## 64STAFF REPORT COMMUNITY DEVELOPMENT DEPARTMENT

HEARING DATE: 12/15/2020  
TO: Mayor & City Council  
FROM: Alan Tiefenbach, Associate Planner  
208-489-0573  
SUBJECT: H 2020-0010  
Brody Square Final Plat  
LOCATION: The site is located within the northeast quadrant of N. Black Cat Road and W. McMillan Road., in the SW ¼ of Section 27, Township 4 N., Range 1W.

Final plat consisting of 64 buildable lots, and 9 common lots on 14.5 acres of land in the R-8 zoning district developing in a single phase.

D. Final Plat Landscape Plan (date: 10/12/2020)

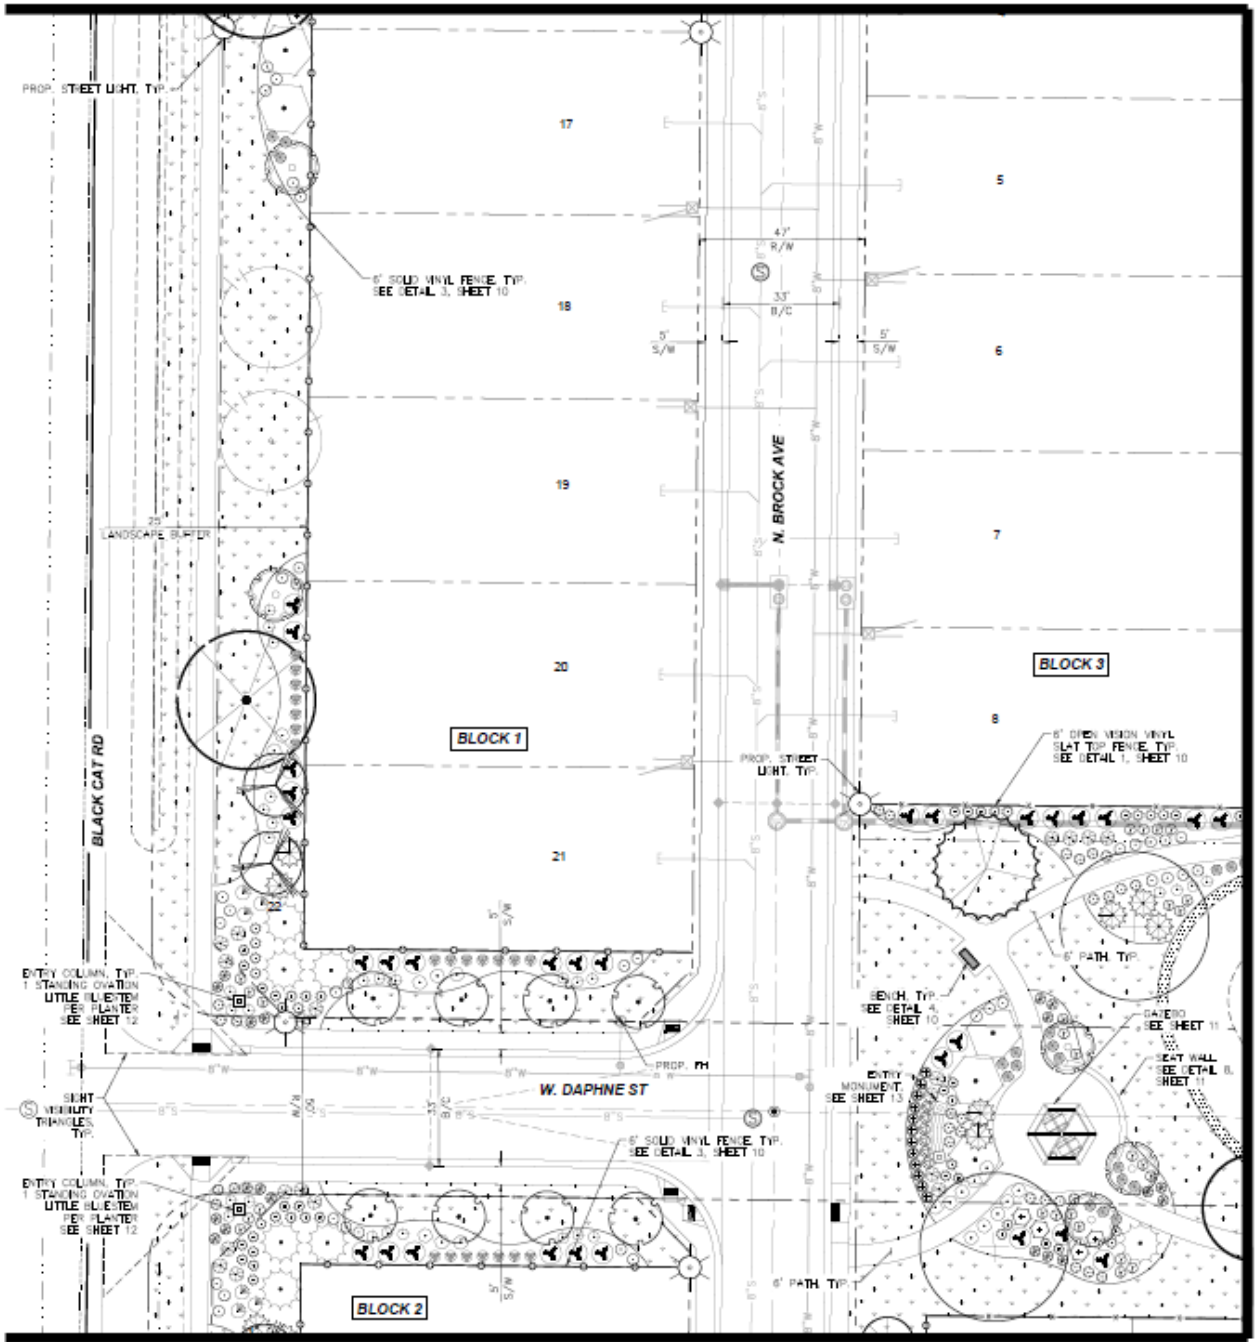
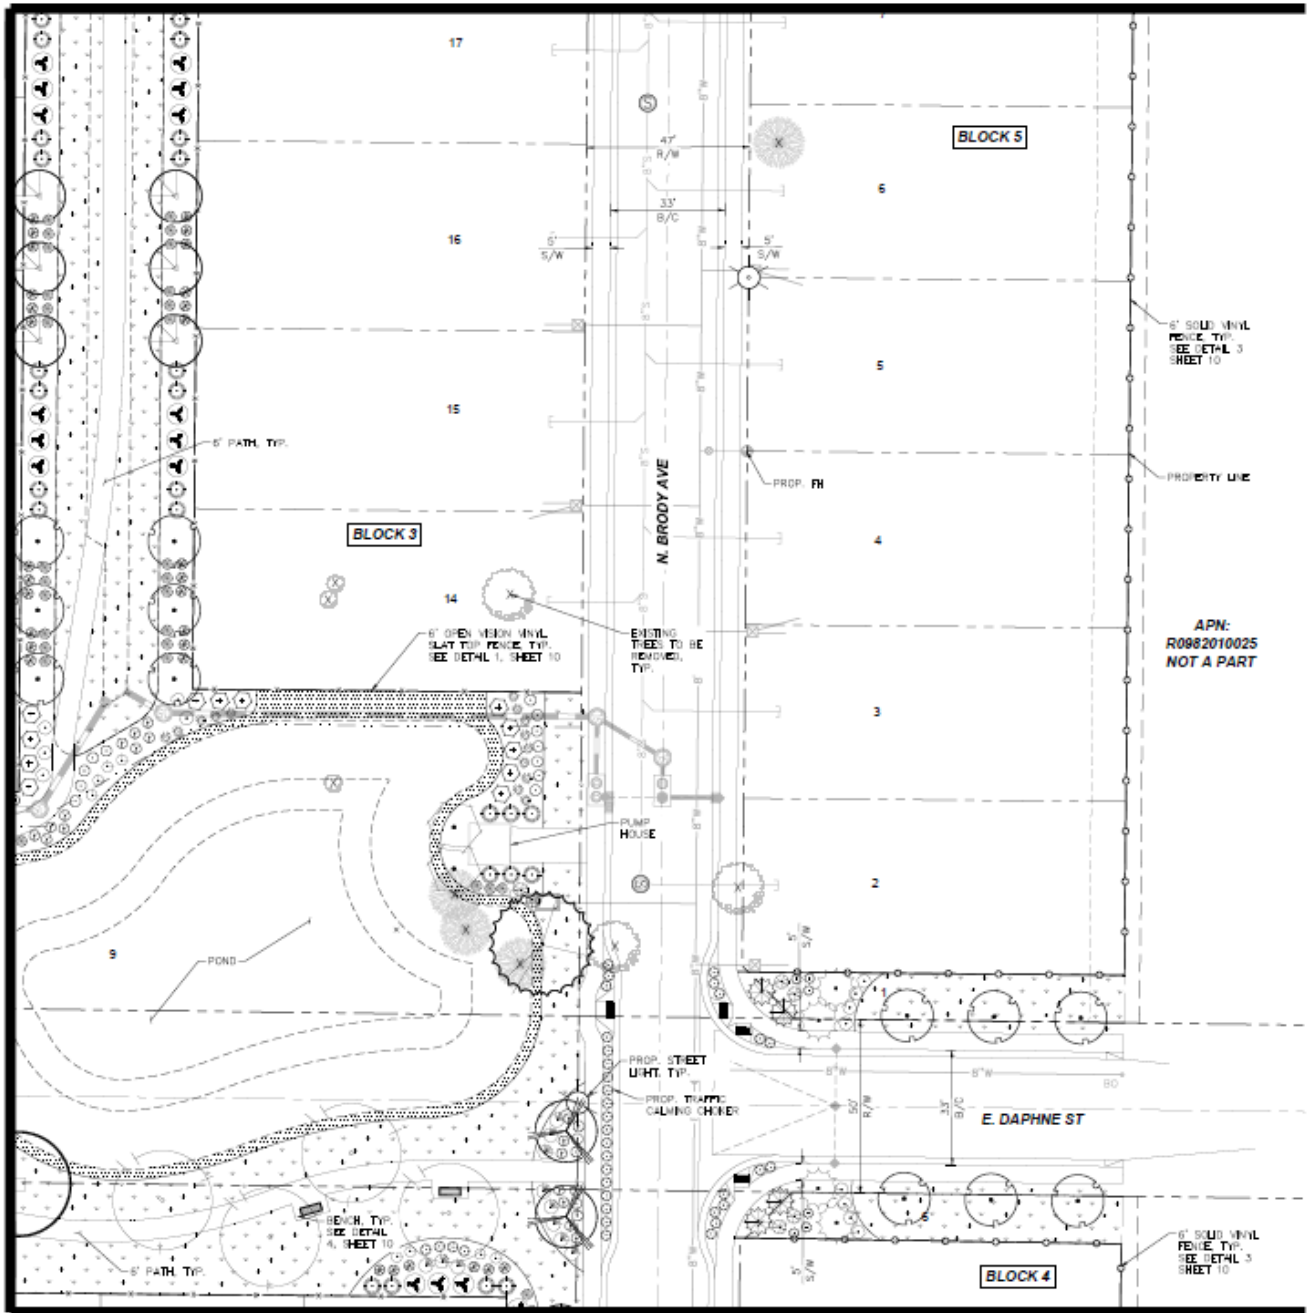
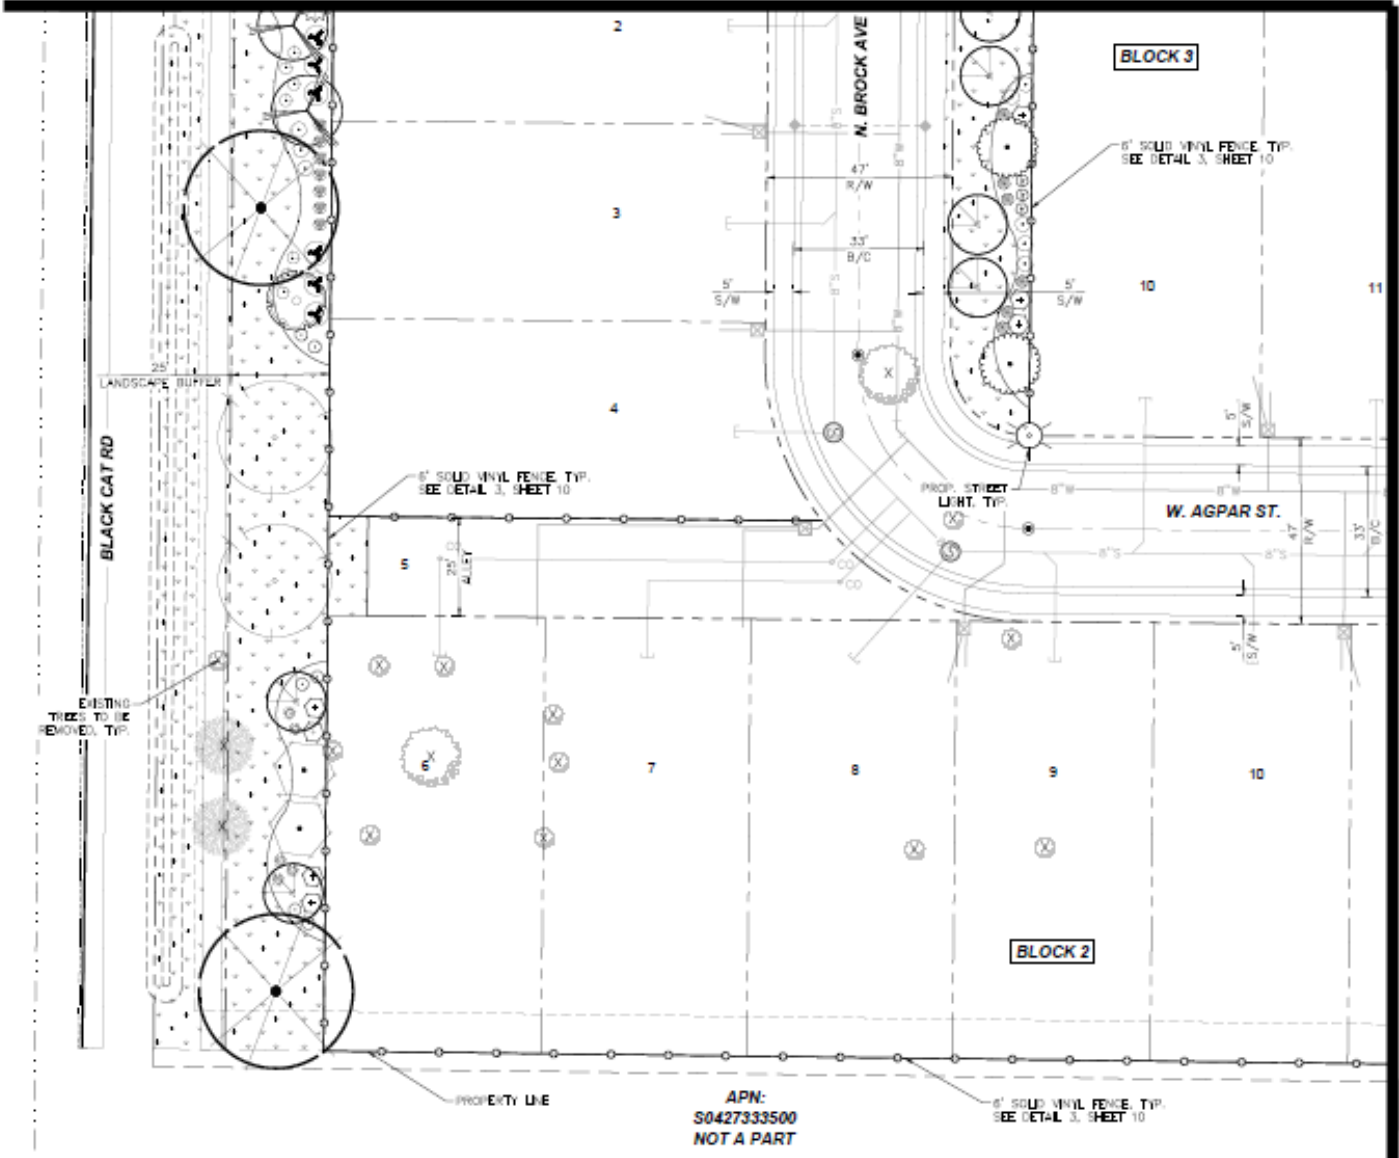
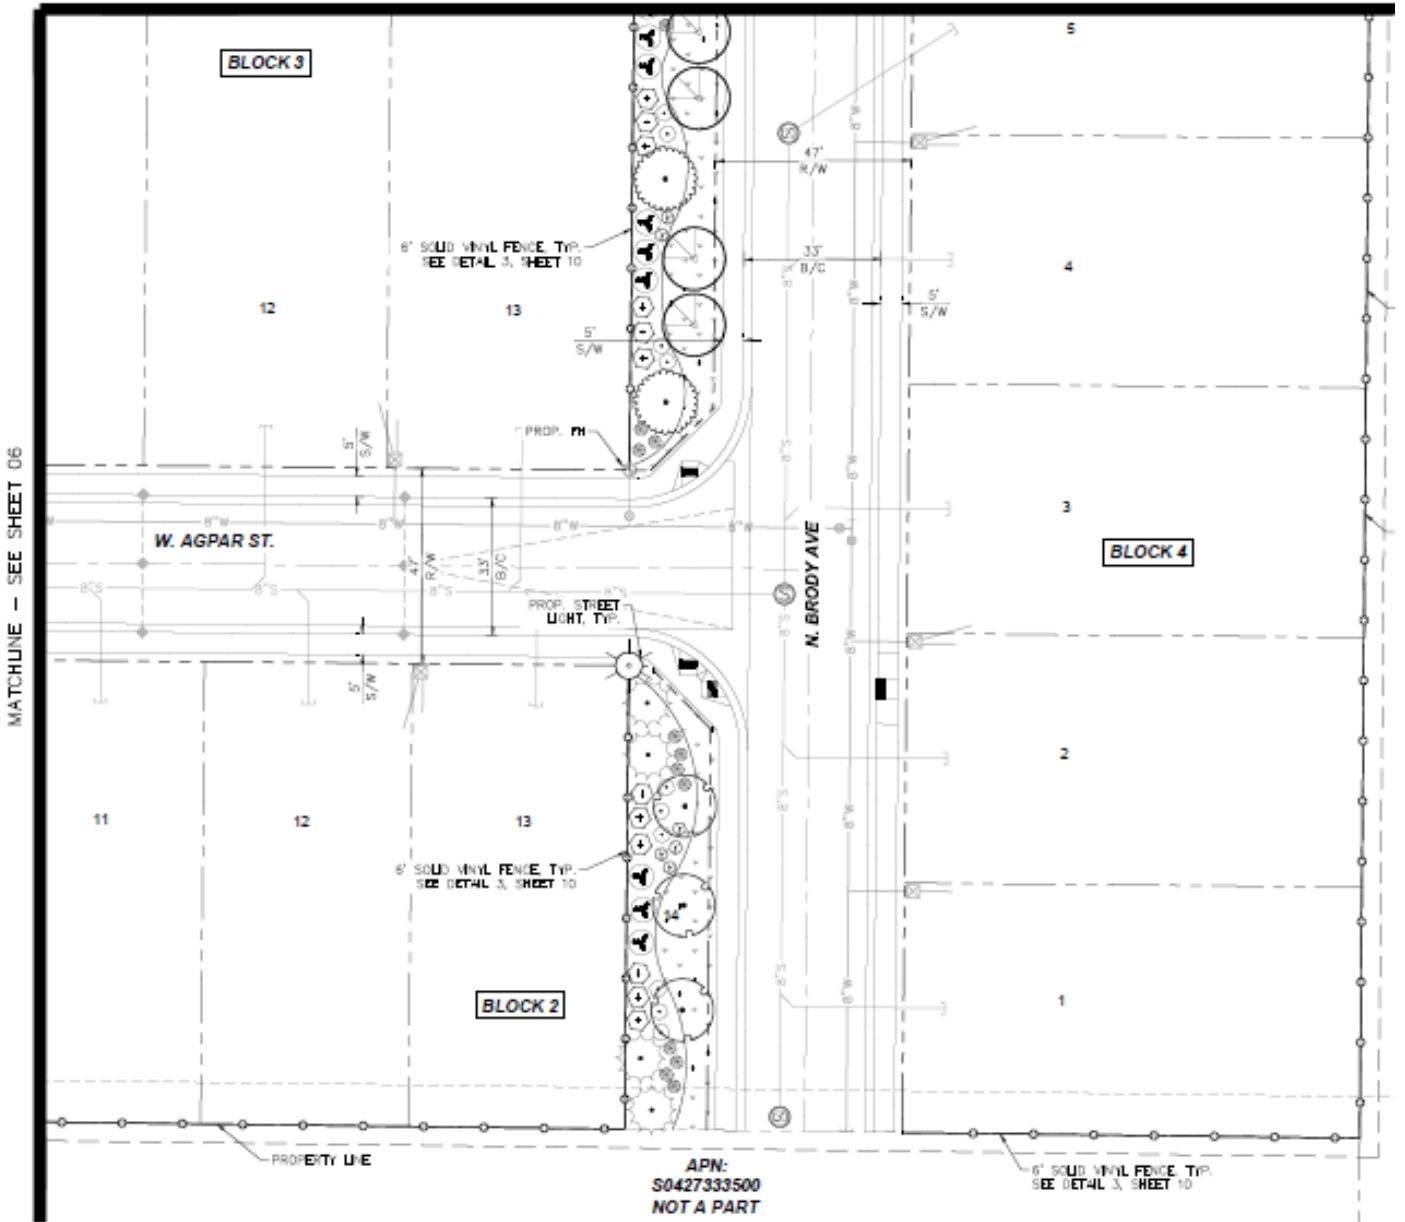
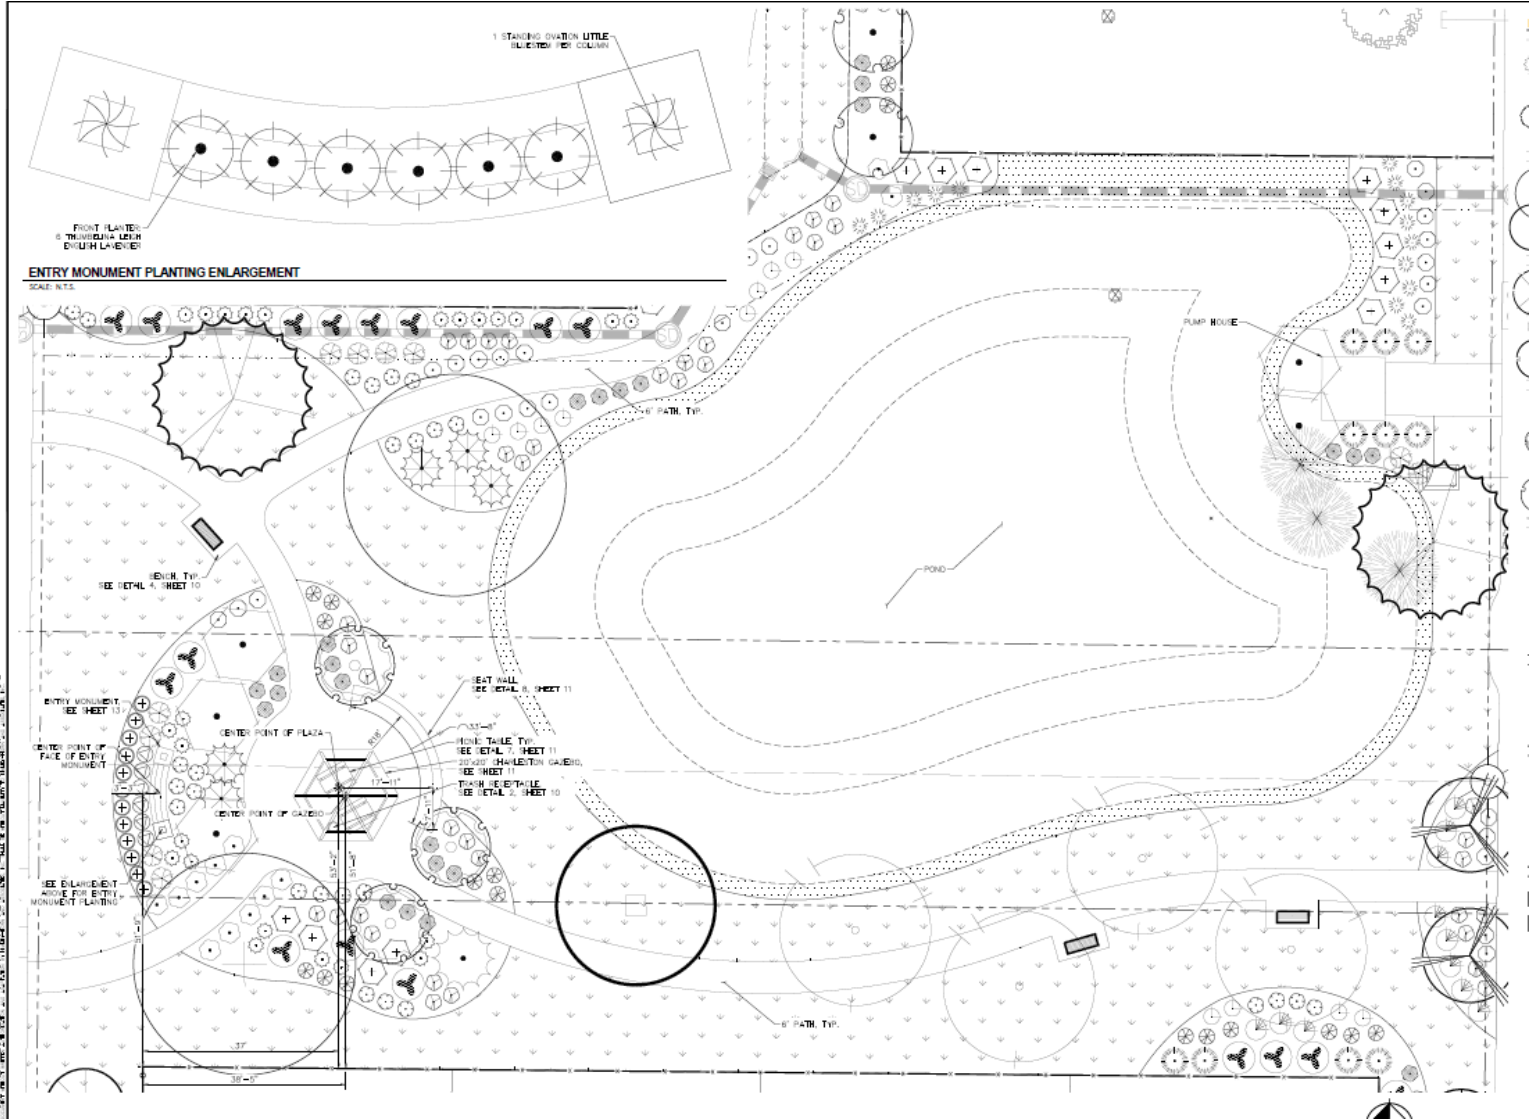
- c. Note 10: Add Development Agreement Instrument Number 2020-138110.
  - d. Note 12: Add ACHD License Agreement Instrument Number.
5. Prior to the City Engineer signature on the final plat, the landscape plan, prepared by Kimley Horn, dated 10/12/2020, included in Section V.D shall be revised to include a mitigation plan approved by the City Arborist which indicates the total number and caliper inches of trees proposed for removal and the total number of replacement trees proposed.

6. Prior to the City Engineer signature on the final plat, the landscape plan, prepared by Kimley Horn, dated 10/12/2020, included in Section V.D shall be revised to depict 5-foot wide landscaped buffers to separate the paved surface of the driveway from the fence on all common driveways which contain solid fencing per UDC 11-6C-3D.5.
